Woodstock Landfill

Engineering Technical Report Addendum 1

DOCUMENT OWNER	
Document Owner:	Woodstock Quarries Ltd
Document Name:	Woodstock Landfill Engineering Report – Addendum 1

This Addendum is to be read in conjunction with Appendix 5 Engineering Report of Application

Figure 4.2: Interface between HDPE/GCL liner and polyurea membrane.

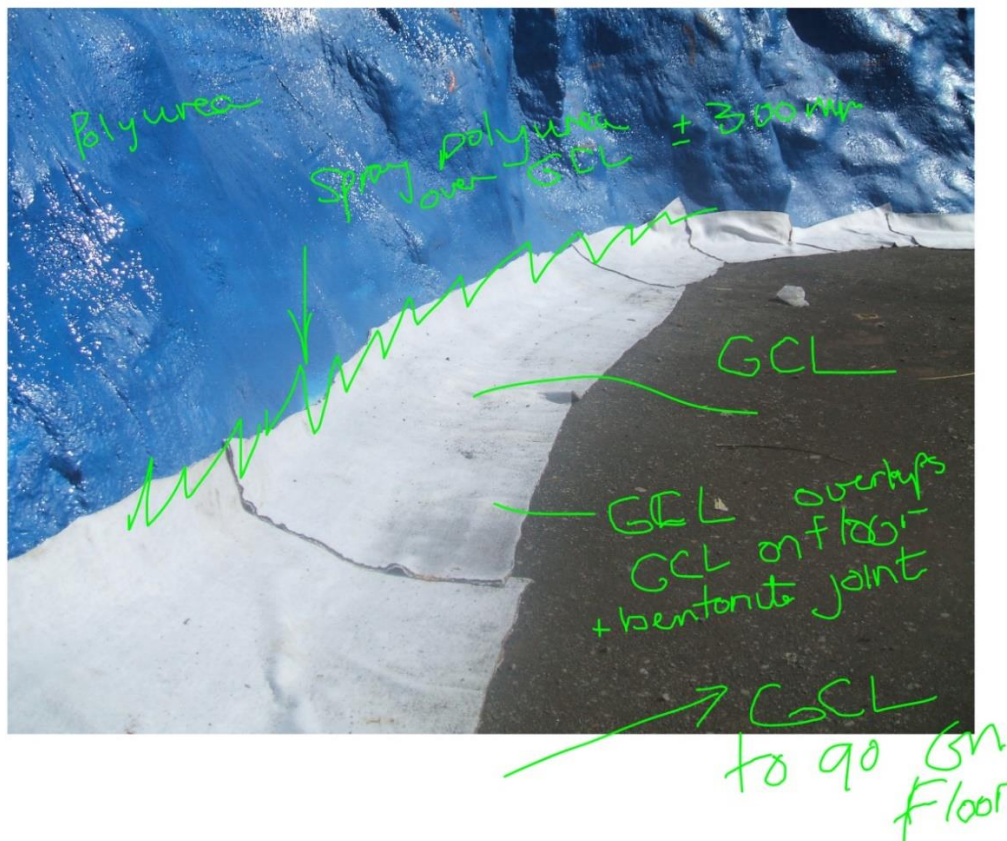
There are well established techniques for constructing the interface between the HDPE / GCL liner system of the base of the landfill and the polyurea on the rockwalls. An example of this is shown in the photograph below (Figure 4.2).

Figure 4.3: Laboratory and field measurements of liner seepage through known defects (Rowe et al).

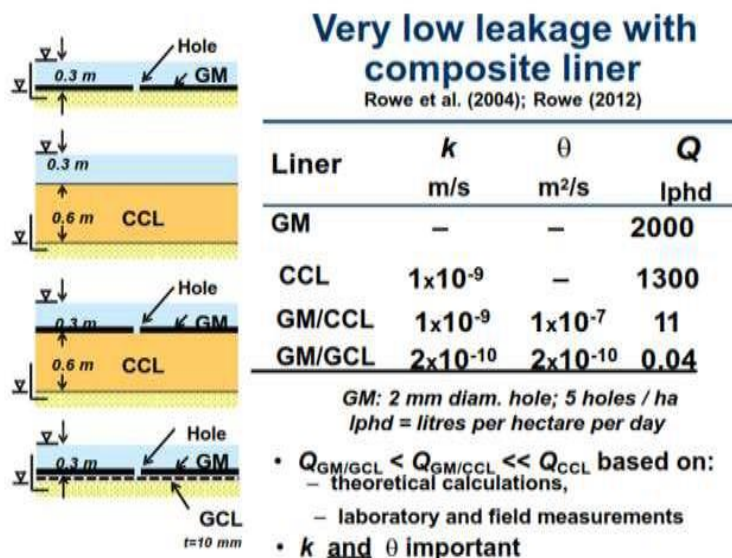
Methods have been developed for calculating leakage through defects in a composite lining system make due allowance for the contact between the HDPE geomembrane and the underlying clay or GCL. Field and laboratory measurements of actual leakage through different lining system have been undertaken by Rowe et al, and the results are shown in Figure 4.3 below. The figure clearly shows the incremental benefit between a geomembrane (GM). or clay (CCL), liner alone compared to a composite HDPE / GCL lining system as shown in the bottom example, the same system that is proposed for the Woodstock Landfill. The research suggests that leakage rates in the order of 0.04 litres per hectare per day could be expected. It is recommended that for a conservative assessment of the impact of the potential leakage of leachate through the liner system a leakage rate of 0.1 litres per hectare per day should be adopted.

Figure 4.4 Installation of drainage gravel against side slopes

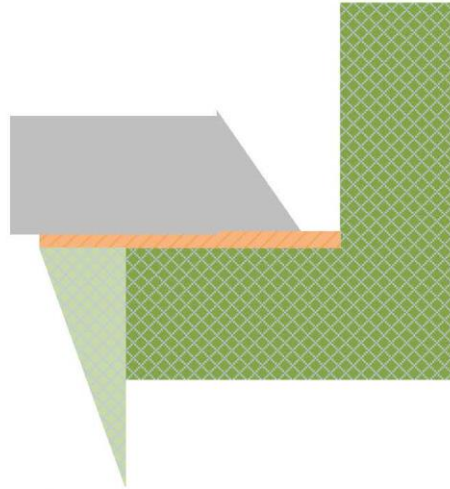
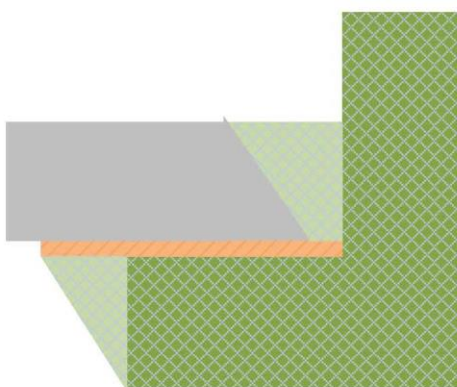
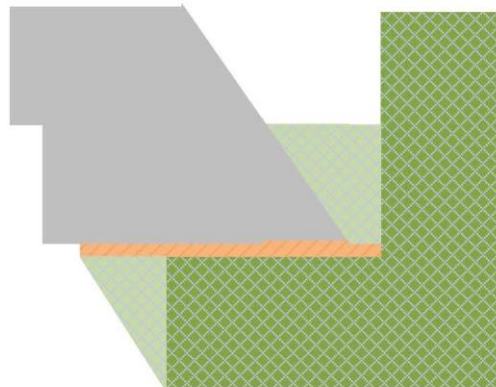
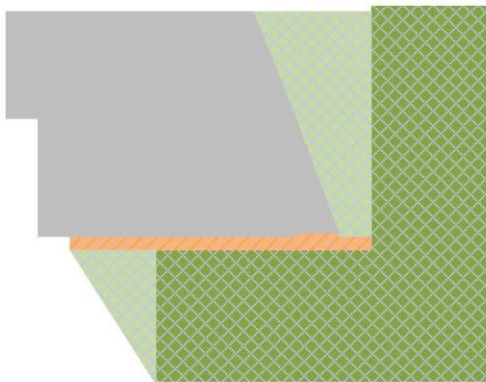
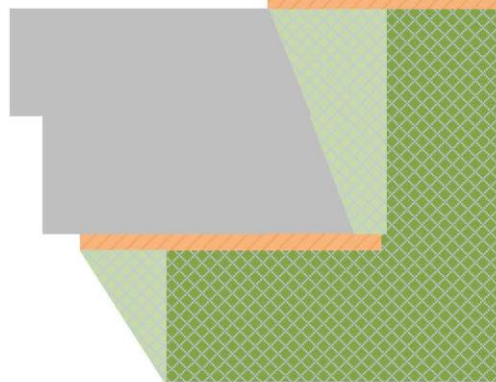
A leachate drainage layer/liner protection layer on the side slopes to convey leachate to leachate collection pipes on the floor and bench areas. The methodology for installing this drainage layer is shown in Figure 4.4 below.
